Access Compliance Report

Public Rights-of-Way

(Curb Ramps)

Intersection ID: 6594	Main Street: DALE_AV	Cross Street: ROOK_RD	Location:	N
ADA ID: 111972D7A95F	Ramp Type: PerpDiag	Initial Pass/Fail: Fail	Overall Compliance: No	Severity Score: 37.5
Codes/Mitigation Info/Possible Solution		Field Measurements/Component Compliance

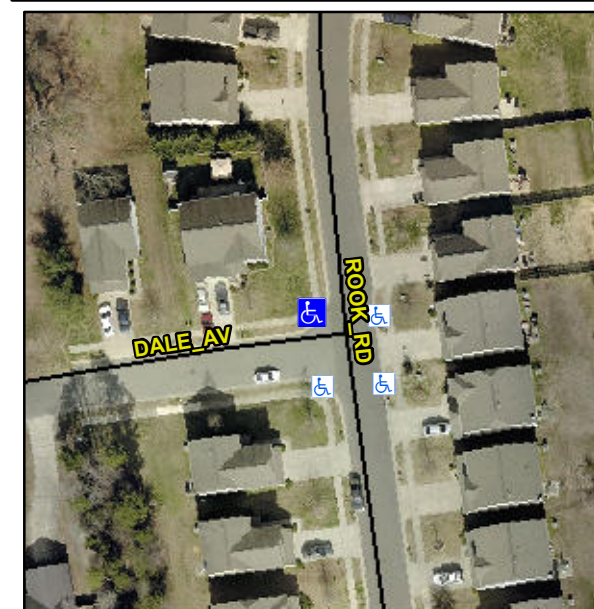
Not Found, R304.2.2, R304.5.3

Compliance	Description	Data	Compliance	Description	Data
N/A	Ramp Length (in)	49.0	No	Ramp Slope (%)	10.0
Yes	Ramp Width (in)	48.0	No	Ramp XSlope (%)	8.6
N/A	Flare Type LT	N/A	N/A	Flare Type RT	N/A
N/A	Flare Slope LT (%)	N/A	N/A	Flare Slope RT (%)	N/A
N/A	Flare Traversable LT?	N/A	N/A	Flare Traversable RT?	N/A
N/A	Landing Length (in)	N/A	N/A	DWS Provided?	N/A
N/A	Landing Width (in)	N/A	N/A	DWS Contrast?	N/A
N/A	Landing Slope (%)	N/A	N/A	DWS Length (in)	N/A
N/A	Landing X Slope (%)	N/A	N/A	DWS Full Width?	N/A
N/A	Landing Curb? (Y/N)	N/A	N/A	DWS Offset (in)	N/A
N/A	Shared Landing?	N/A			
N/A	Gutter Ponding?	N/A	N/A	Gutter Slope (%)	N/A
N/A	Gutter Lip Ht (in)	N/A	N/A	Gutter X Slope (%)	N/A
N/A	Painted X Walk1?	No	N/A	Painted X Walk2?	No
	X Walk 1 Direction	To W		X Walk 2 Direction	To S
N/A	X Walk 1 Width (in)	N/A	N/A	X Walk 2 Width (in)	N/A
	X Walk 1 Slope (%)	4.2		X Walk 2 Slope (%)	1.7
	X Walk 1 X Slope (%)	3.1		X Walk 2 X Slope (%)	4.5

Remove & Replace Curb Ramp With Two New Directional Ramps or Equivalent.
